# UNITED STATES PATENT AND TRADEMARK OFFICE

APPLICATION NO.	FILING DATE	FIRST NAMED INVENTOR	ATTORNEY DOCKET NO.	CONFIRMATION NO.
09/619,479	07/19/2000	Shunpei Yamazaki	0756-2188	1883

**Office Action Summary**

## DETAILED ACTION

**FIG. 11A**

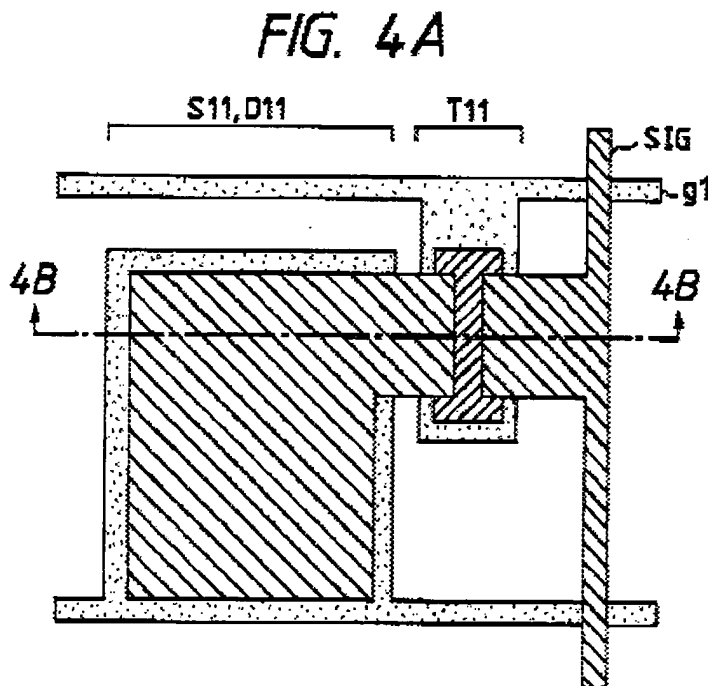
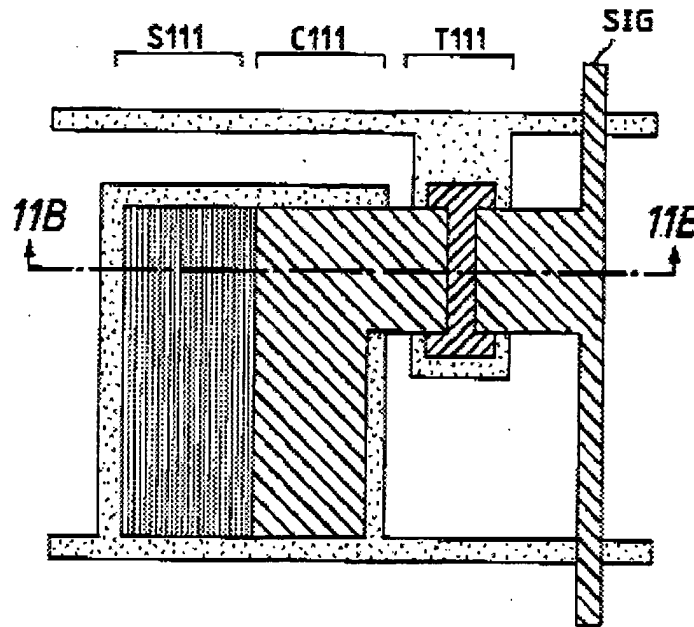
As to claims 1, 23, 25, and 29, Kaifu discloses an embodiment (col. 14, line 53 through col. 17, line 13) that is explained in part by Figures 3, 4A, and 4B, (col. 5, line 26 through col. 14, line 52) wherein an integral image recognition/display apparatus comprises: a plurality of pixel portions, D11, each having an active device, T11, and arranged in matrix and each having a pixel electrode (left portion in Figure 4B), comprising 10,000 angstrom thick layer of aluminum (Applicant's a reflecting material), 6, and n-doped silicon (Applicant's light-transmitting material), 5, (Applicant's pixel electrode comprises a first layer and a second layer, said second layer provided over

Please note: the difference between the embodiment of Figure 11B and that of Figures 4B is 11B performs the image input and display on the top side as opposed to 4B

Please also note: in Figure 11B pixel electrode, 6, is energized for image display which also necessarily energizes transparent n-type silicon structure, 5, that functions as a transparent pixel electrode in the display mode.

It is respectfully pointed out that Kaifu discloses the removal (col. 7, lines 12-22) of a portion of the reflective aluminum electrode, 6, as may be found in Figures 11A and 11B (Applicant's wherein a plane parallel to a direction of said matrix is divided into at

least a first display region and a second display region in said pixel electrode, wherein said pixel electrode comprises a reflecting material, 6, in said first display region, and wherein said pixel electrode comprises a light-transmitting material, 5, in said second display region). Please note: said pixel electrode, 6, has an image display function (col. 11, line 66 through col. 12, line 10; see also incident light ray L2 and reflected light ray L3 in Figure 4B). The difference between the embodiment of Figure 11B and that of Figures 4B is 11B performs the image input and display on the top side as opposed to 4B performing the image input on the bottom side and the image display on the top side. Please also note: 11B energizes pixel electrode, 6, for image display which also necessarily energizes transparent n-type silicon structure, 5, that functions as a transparent pixel electrode in the display mode.

**FIG. 11B**

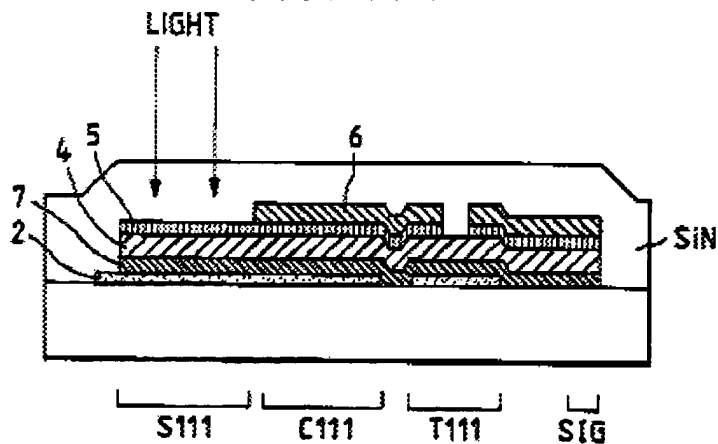
wherein said pixel electrode, 6, has an image display function (col. 11, line 66 through col. 12, line 10; see also incident light ray L2 and reflected light ray L3 in Figure 4B).

FIG. 1

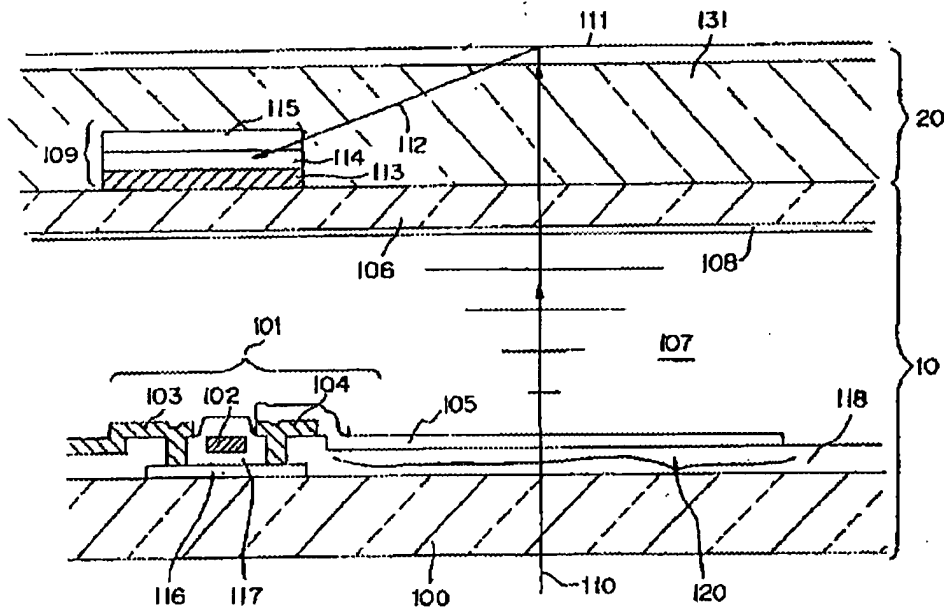
Itoh teaches the use of a top gate TFT, 101, in an integral image recognition/display apparatus in Figure 1 as an art recognized means suitable for the intended purpose of comprising a TFT for improved switching (turning on and off) of the pixel electrodes (MPEP 2144.07) (col. 5, lines 3-11).

Itoh is evidence that ordinary workers in the art of liquid crystals would find the reason, suggestion, or motivation to add top gate TFTs as an art recognized means suitable for the intended purpose of comprising a TFT for improved switching of the pixel electrodes (col. 5, lines 3-11).

Therefore, it would have been obvious to one having ordinary skill in the art of liquid crystals at the time the invention was made to modify the integral image recognition/display apparatus of Kaifu with the top gate TFTs of Itoh as an alternate means providing design and manufacturing flexibility for improved switching of the pixel electrodes.

Itoh teaches in Figure 1 the use of a plurality of sensor portions, 109, disposed in matrix over an opposed substrate, 106, constituting a display panel, wherein said sensor portion has a photo-electric conversion device (col. 4, lines 36-42), and can read information by utilizing the rays of light, 110, transmitting through said light-transmitting material when an external image, 111, is read.
